PWR Small Break LOCA Evaluation Model, S-RELAP5 Based

EMF-2328(NP)(A)
Revision 0
Supplement 1(NP)(A)
Revision 0

**SUBJECT: FINAL SAFETY EVALUATION BY THE OFFICE OF NUCLEAR REACTOR
REGULATION FOR TOPICAL REPORT EMF-2328(P)(A), REVISION 0,
SUPPLEMENT 1, REVISION 0, "PWR [PRESSURIZED WATER REACTOR]
SMALL BREAK LOCA [LOSS-OF-COOLANT ACCIDENT] EVALUATION MODEL,
S-RELAP5 BASED" (TAC NO. ME8227)**

TOPICAL REPORT EMF-2328(P)(A), REVISION 0, SUPPLEMENT 1, REVISION 0

Figure 1-2: Flow Rate through the Break

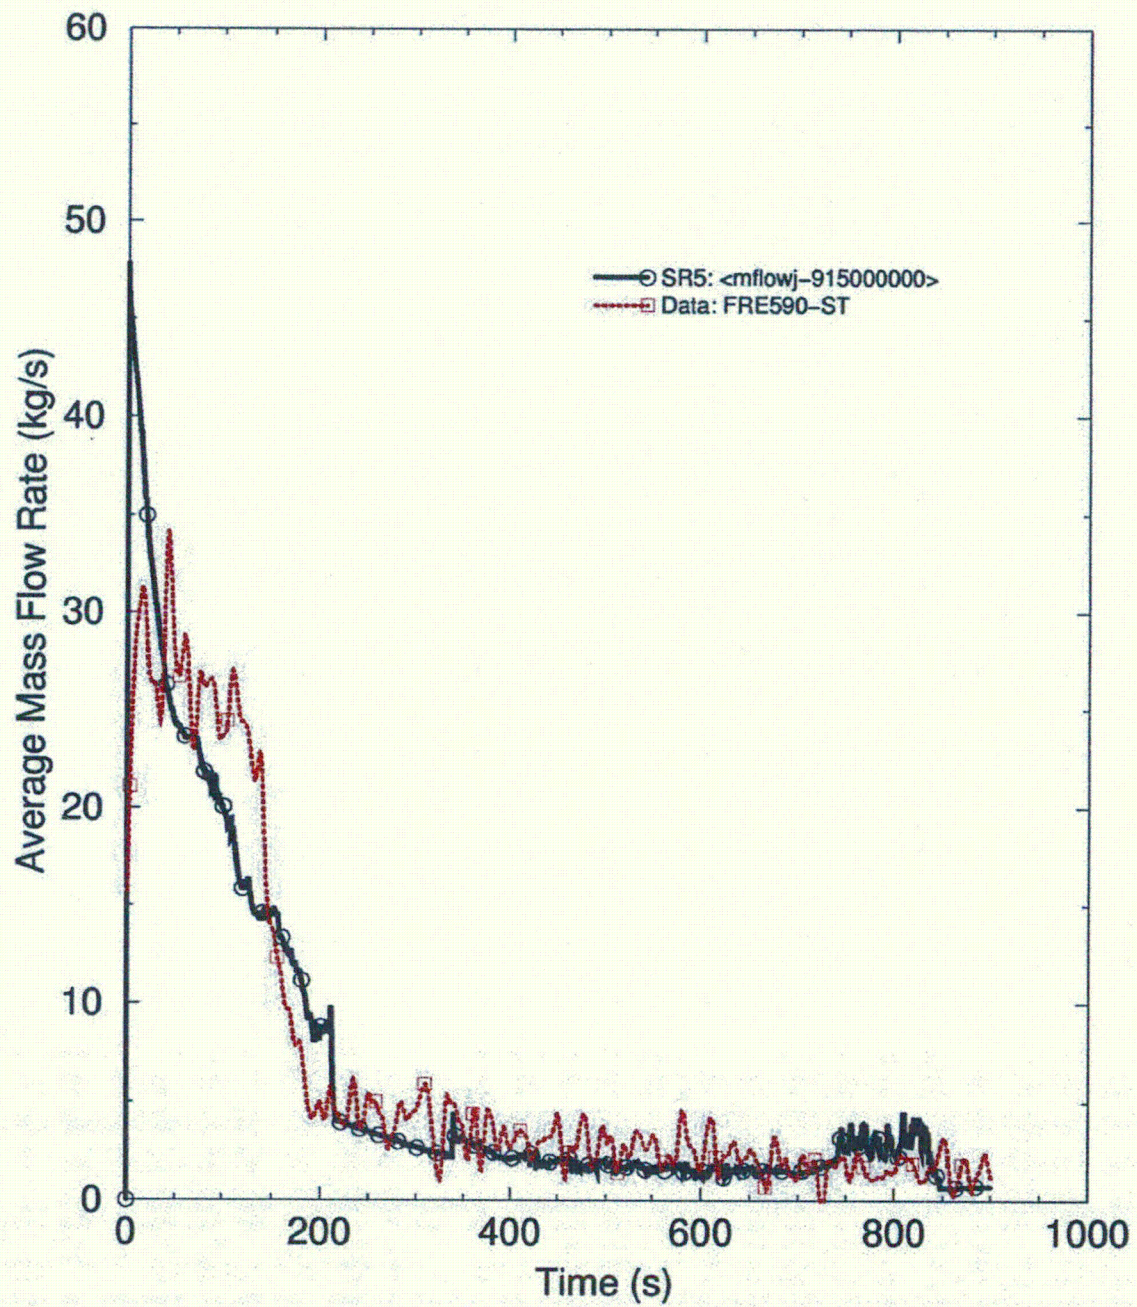
Figure 1-2 shows that S-RELAP5 initially predicts a higher break flow than measured, and then under-predicts the flow until 150 seconds. After about 200 seconds, the correlated break flow, when the flow is high quality steam, approximates the measured flow. The comparison of the correlated primary and secondary pressure with the test data is presented in Figure 1-3. S-RELAP5 estimates the primary system pressure reasonably well until primary pressure drops below secondary pressure shortly after 200 seconds. The code then calculates a faster primary depressurization rate during the 200-350 second period.

Figure 1-4: Intact Loop Steam Generator-A Tubes Upflow Differential Pressure

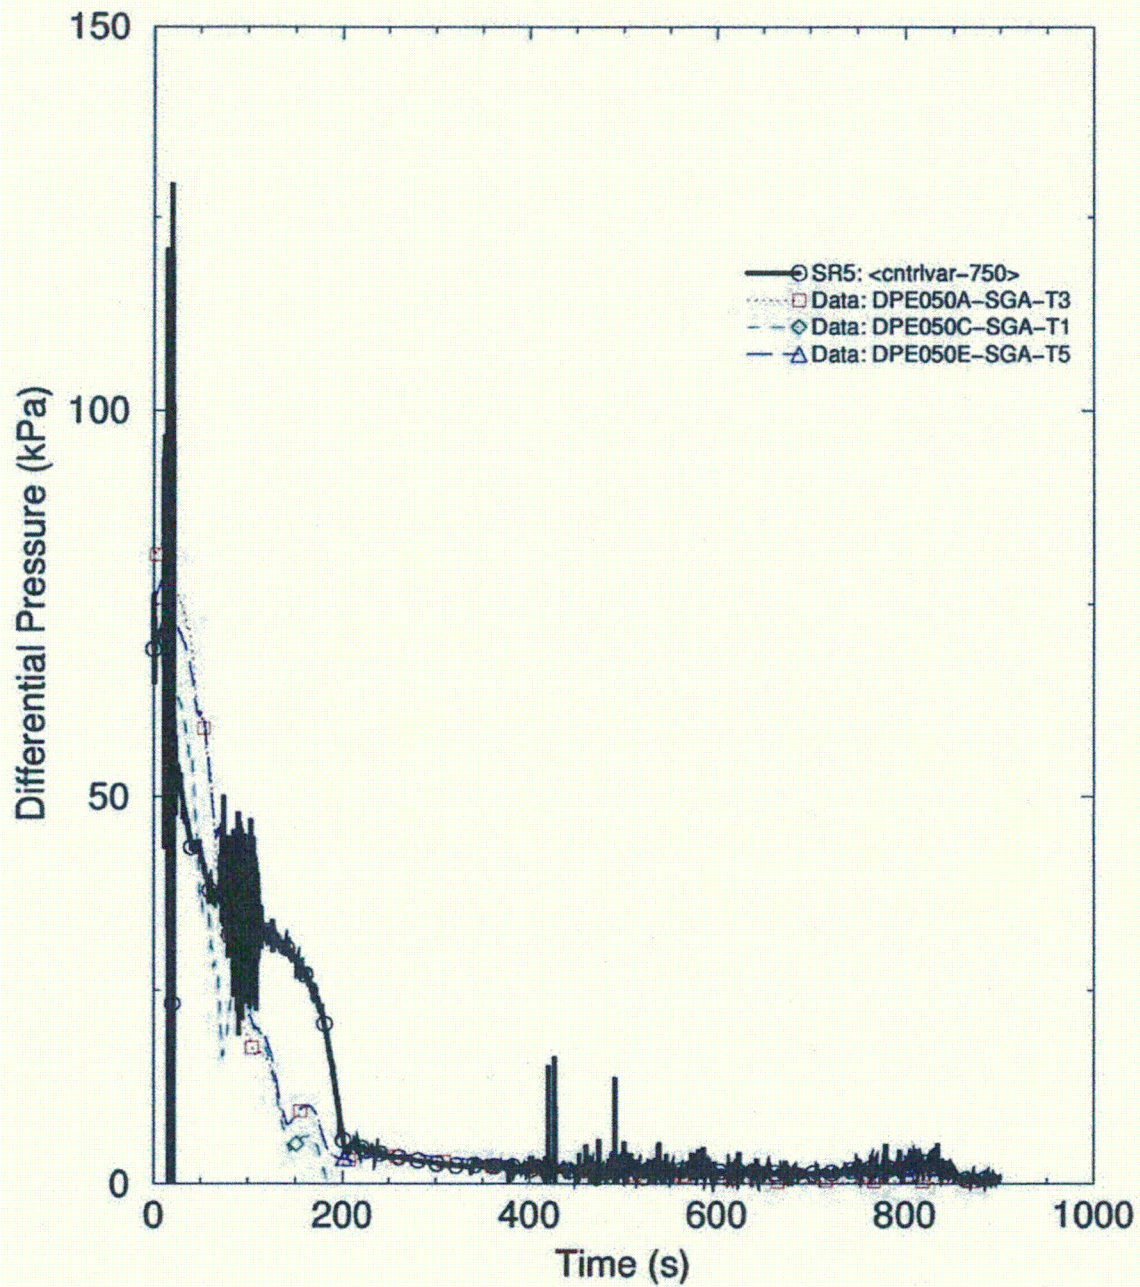
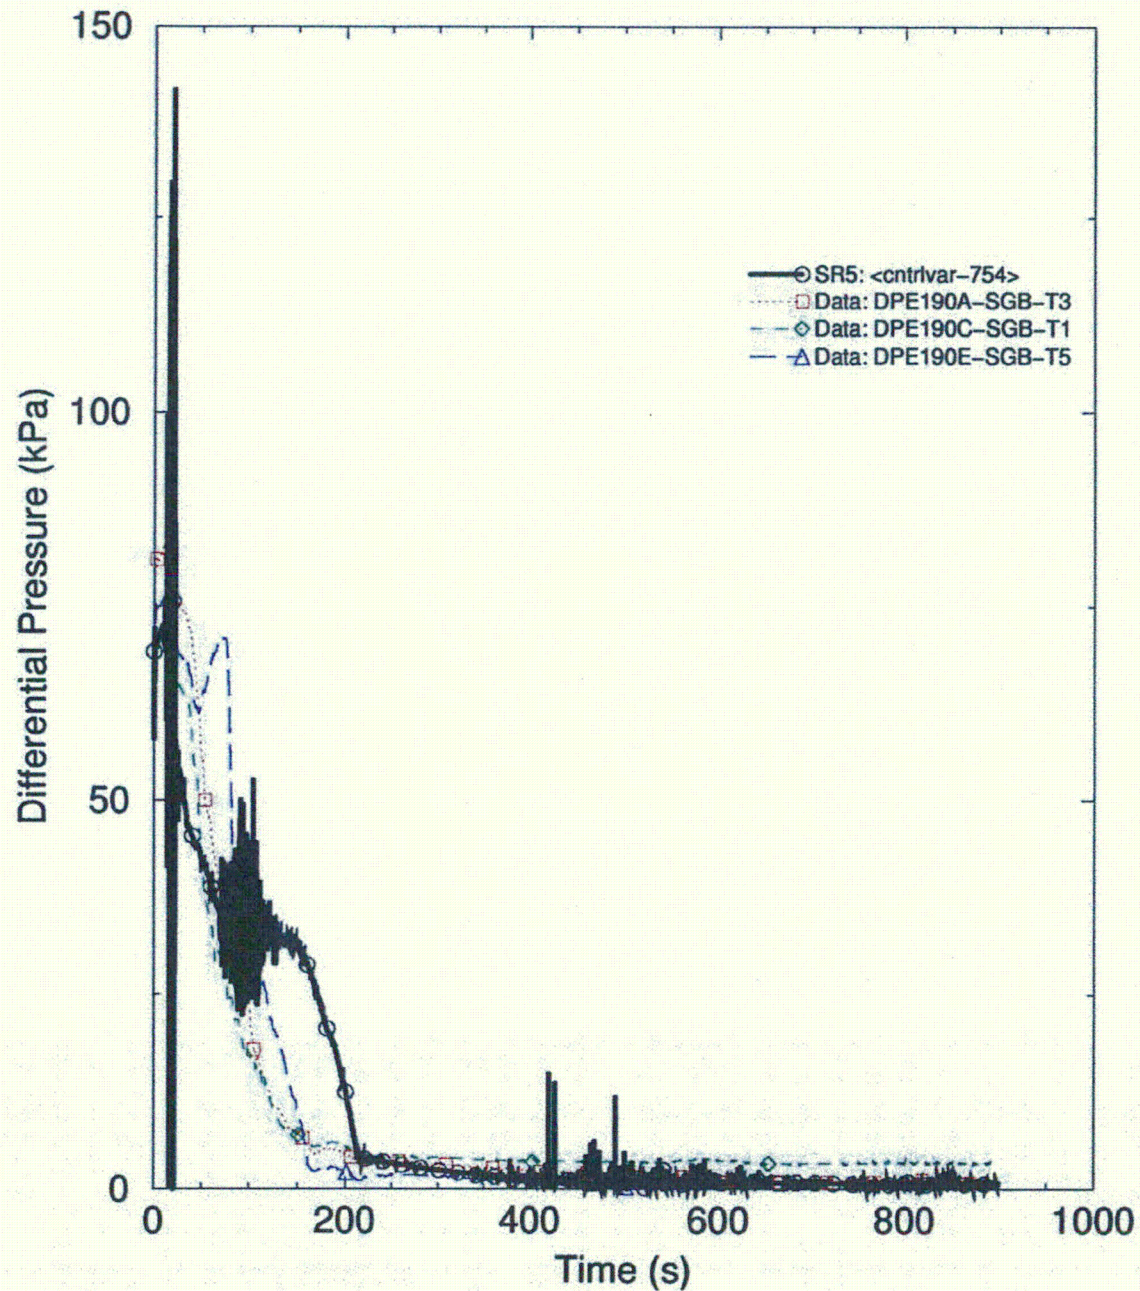
Figure 1-4 and Figure 1-5 compare the calculated and measured differential pressure across the upflow tubes of the steam generators in the intact (Loop A) and broken loop (Loop B), respectively. As seen in these figures, when the measured pressure difference drops at approximately 70 seconds, the pumps lose their ability to force flow through the system because of two-phase degradation. S-RELAP5 over-predicts the fluid retained in the tubes until approximately 200 seconds, approximately coincident with the time when the break flow becomes high quality steam.

Figure 1-4 and Figure 1-5 show that from 70 seconds to around 200 seconds the S-RELAP5 drag or CCFL models hold substantially more liquid in the SG up-flow tubes than occurred in the test. That in turn leads to more voided core flows during loop draining and an early cladding heat up starting around 70 seconds, as shown in Figure 1-8. Between 70 and approximately 140 seconds, the core liquid fraction in the test remains high enough to keep the cladding near saturation. During this time period, the code predicts there is significantly more liquid in the loops, principally in the SG tubes and the broken loop pump seal, than was indicated in the test. This observation is supported by the calculated heatup shown in Figure 1-9 through Figure 1-12. At approximately 110 seconds, the liquid in the SG tubes starts to drain back to the core initiating additional cooling. This cooling reduces the cladding temperature at the core exit but only stabilizes or slows the temperature excursion in the middle core regions. This is supported by Figure 1-13 and Figure 1-14, which compare the measured and calculated pressure difference across the core and the downcomer, respectively.

Figure 1-6: Broken Loop Pump Suction Seal Upflow DP

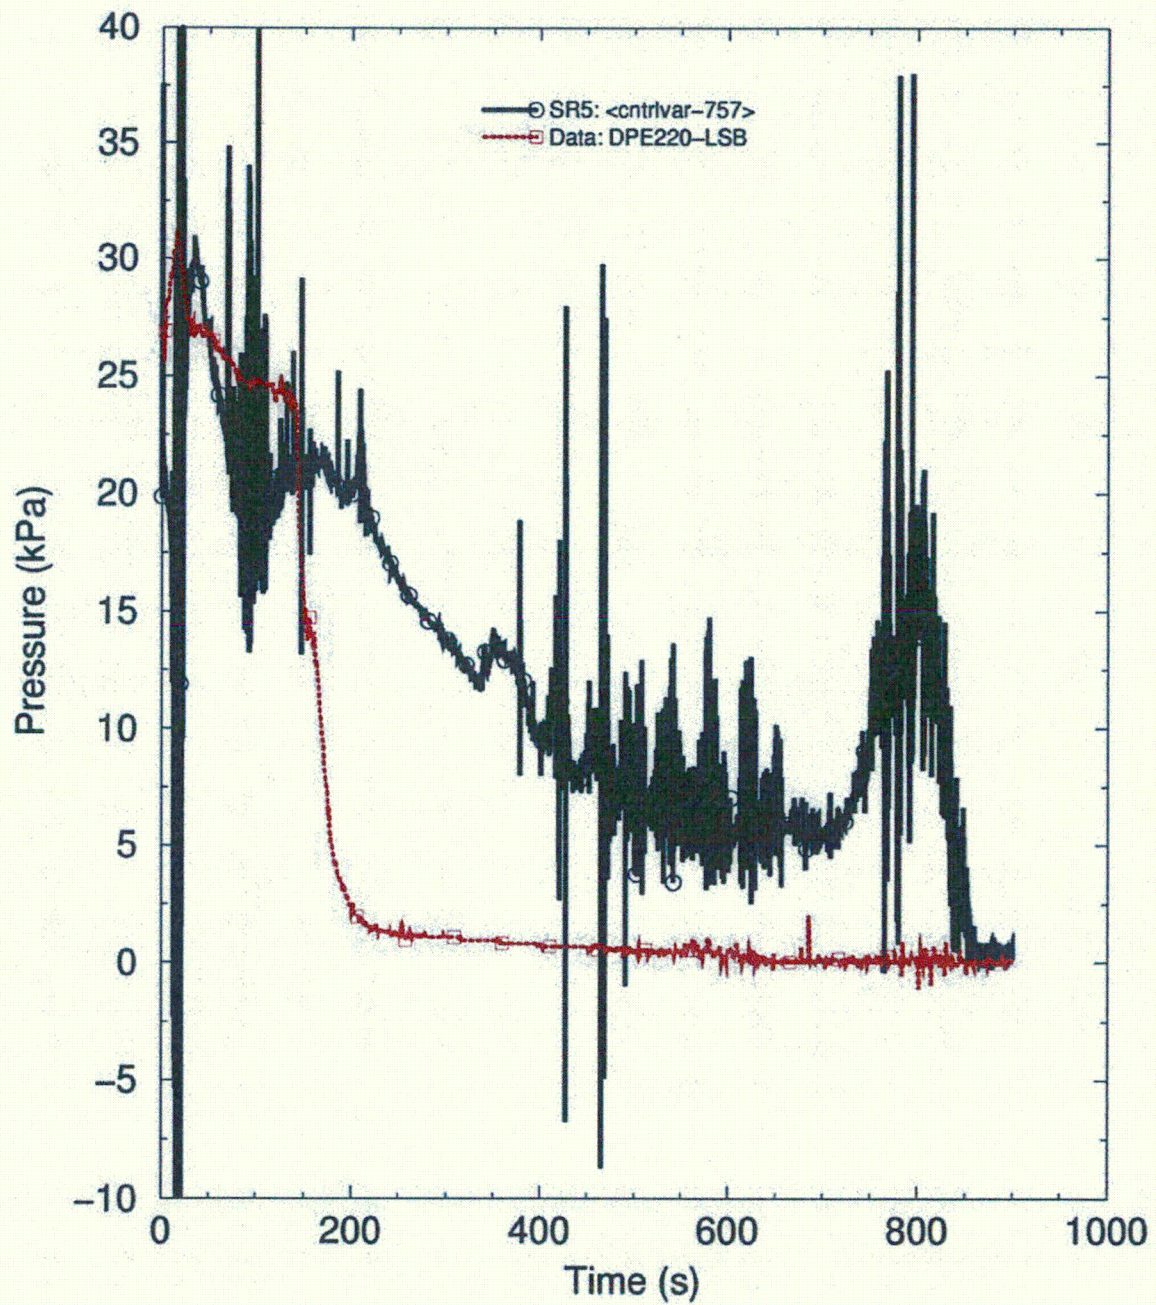
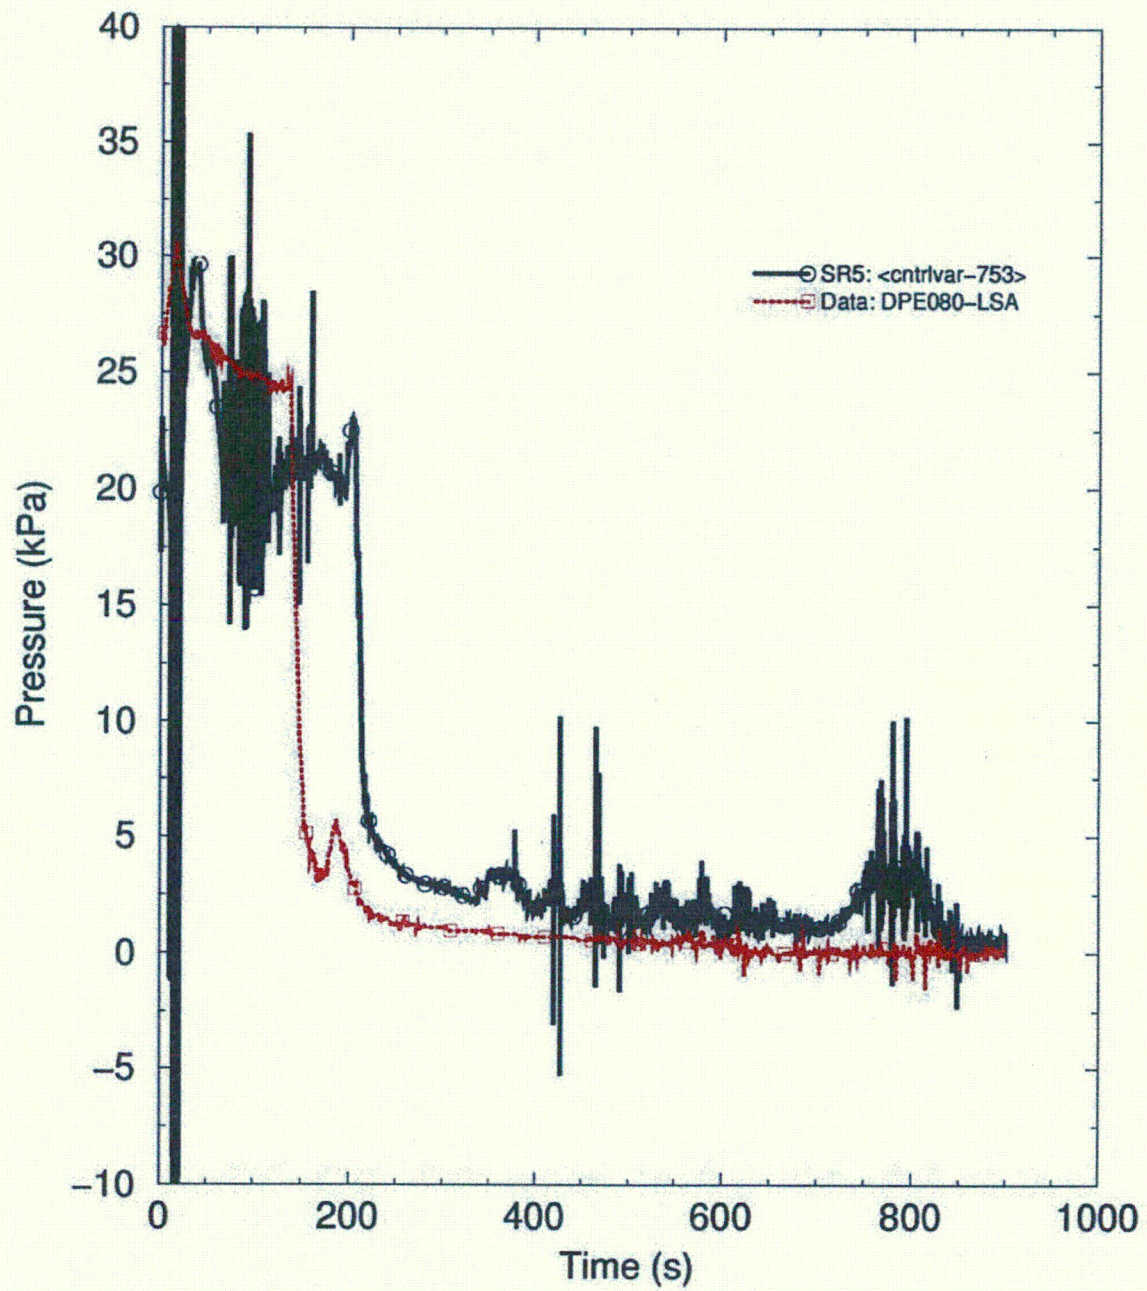
Figure 1-6 compares the measured and calculated pressure difference across the pump suction upflow in the broken loop (B). This figure indicates that the code does not predict that the loop seal will fully clear during the time that core heatup occurs, although the measurement indicates that the loop seal clears before 150 seconds. Figure 1-7 compares the pump suction upflow differential pressure in the intact loop (A), and indicates that the code does predict that the loop seal will clear, although it is predicted to occur at about 220 seconds compared to the measured value of 140 seconds.

Loop seal behavior in the ROSA-IV benchmark is discussed in the response to RAI 1.1 (Figure 1-6 and Figure 1-7). Both loop seals clear in the test, but the S-RELAP5 run preferentially clears the intact loop seal, somewhat later than the test, resulting in greater core level depression (Figure 1-13) and an over-prediction of cladding heatup (Figure 1-8 through Figure 1-12).

Figure 1-18: Primary System Pressure (Upper Plenum)

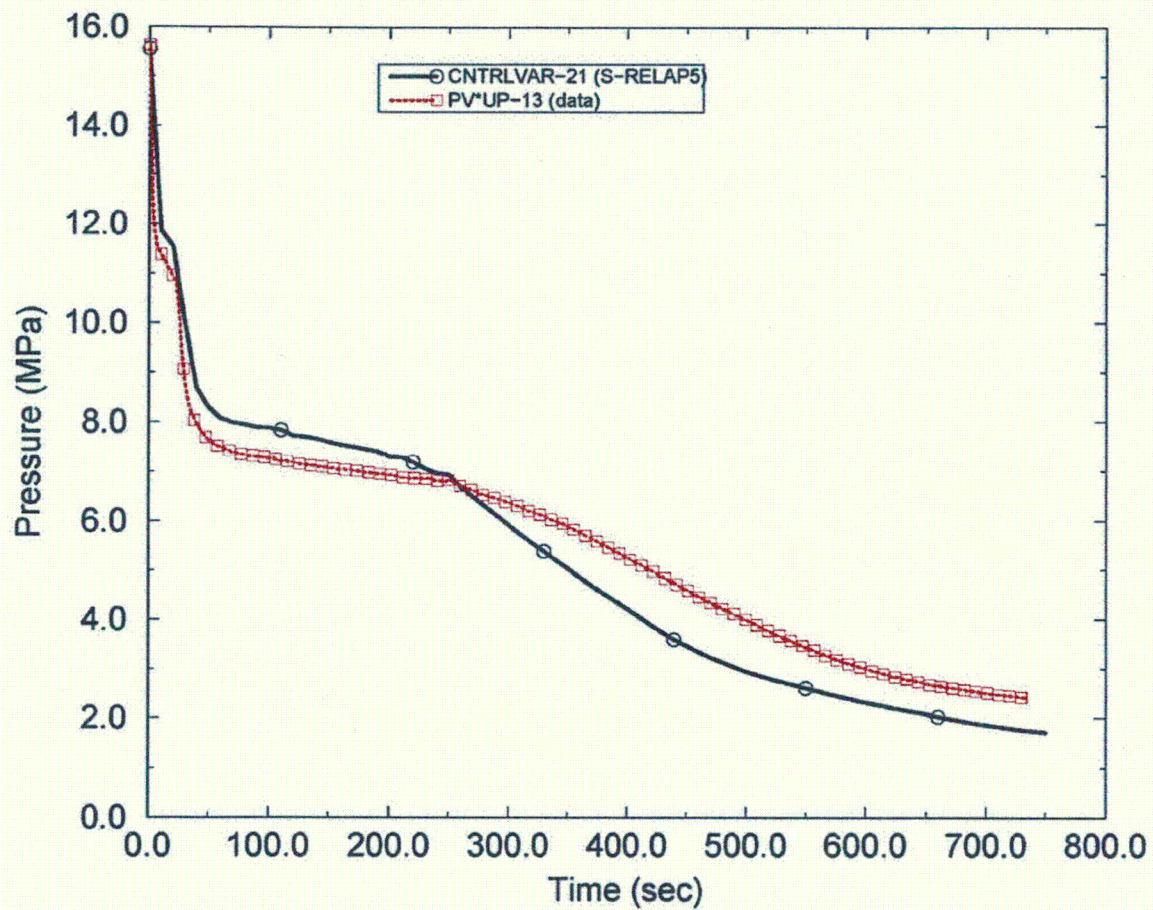
The transient was run for 750 seconds, slightly longer than the test duration of 735 seconds. The initial depressurization of the system is slightly under-predicted by the code in the first 250 seconds (Figure 1-18); however, the mass flow rate from the break matches well during the same time frame (Figure 1-20). The higher primary side pressure is likely due to the higher secondary side pressure. The collapsed liquid level in the intact SG upflow tubes matches the measured data well, emptying at about 200 seconds, as opposed to the 220 second empty time of the experiment (Figure 1-21). The downflow side is similar, with the calculated level emptying about 20 seconds earlier than the test (Figure 1-22), indicating a similar timing of loop seal clearing. This difference in the SG upflow level is the cause of the difference seen in the core liquid level at the time of uncover. While the code calculated data and measured data show similar times of uncovering (Figure 1-23), the code calculated level is slightly higher than the measured data because of the benefit of earlier liquid draining from the SG tubes into the core. With more liquid in the SG U-tubes, the experimental core collapsed level is lower because of the manometric effect. However, this difference in SG tube liquid level is small, and, given the scale of the test, this indicates that the chosen CCFL parameters are reasonable. This is confirmed again by the PCT prediction shown in Figure 1-24, in which the code calculated initial heatup bounds the data. Thus, during the pre-loop seal clearing period with the system hydrodynamics primarily controlled by the break flow and the manometric balance on the up-side and the down-side of the loop S-RELAP5 properly calculated the system behavior including the liquid holdup in the SG tubes and the deep core uncover during this period.

Following core quench, the S-UT-8 test undergoes another heatup during the core boil-off period, which is not predicted by S-RELAP5. The lower primary side pressure during this time period (Figure 1-18) and lower break mass flow rate in the S-RELAP5 calculation shows that the code injects more emergency core cooling (ECC) into the system, and bypasses less ECCS out the break than the test. During this boil-off period, the system response is a result of the net balance between various aspects, including the core boiling, condensation on ECC water in the cold legs, ambient heat loss, ECC bypass and the break flow.
